FIRST FLOOR PLAN  
SCALE 1:100 @ A0

**RESIDENTIAL FLAT**  
BUILDING - 1147, 1149  
PACIFIC HWY & 2 BOBBIN  
HEAD ROAD PYMBLE  
Drawing No. SK06B

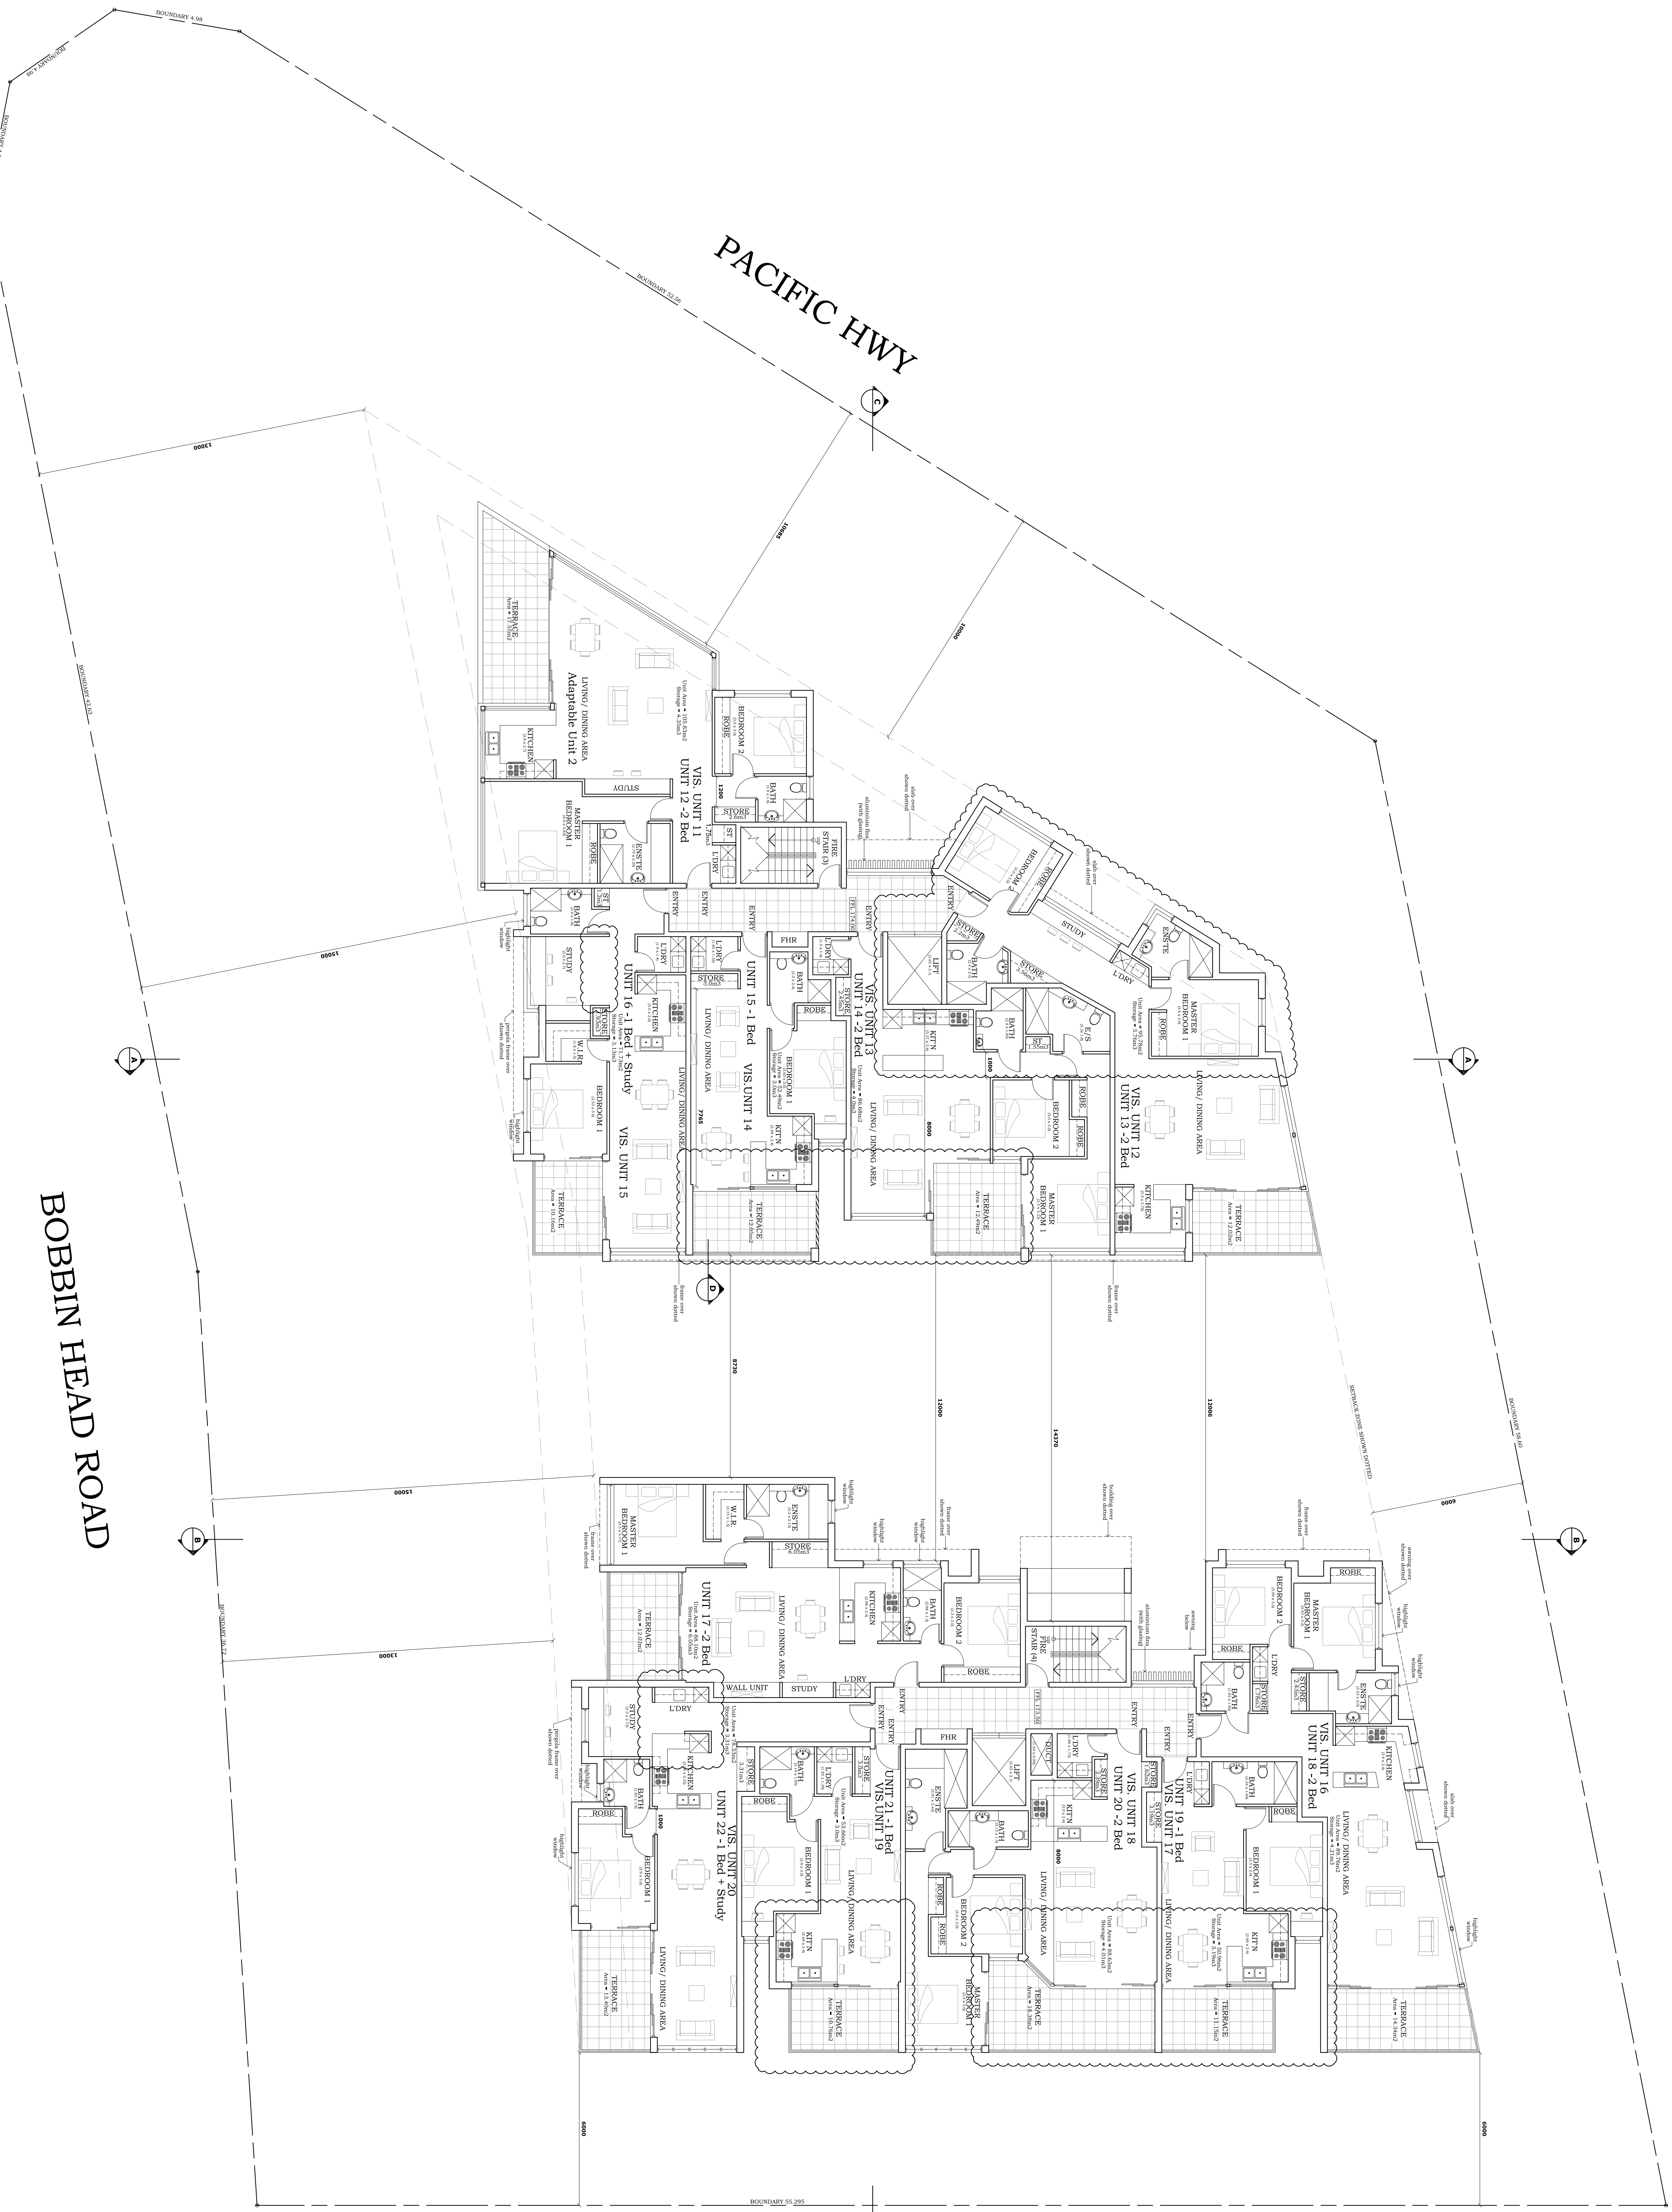
REV	AMENDMENTS	DATE
B	- Lift in southern block has been relocated. - Units 13, 14, 15, 19, 20 & 21 have been reconfigured so that the kitchen are no more than 8m to a window - Wall has been removed from study of units 16 & 22	06.12.11
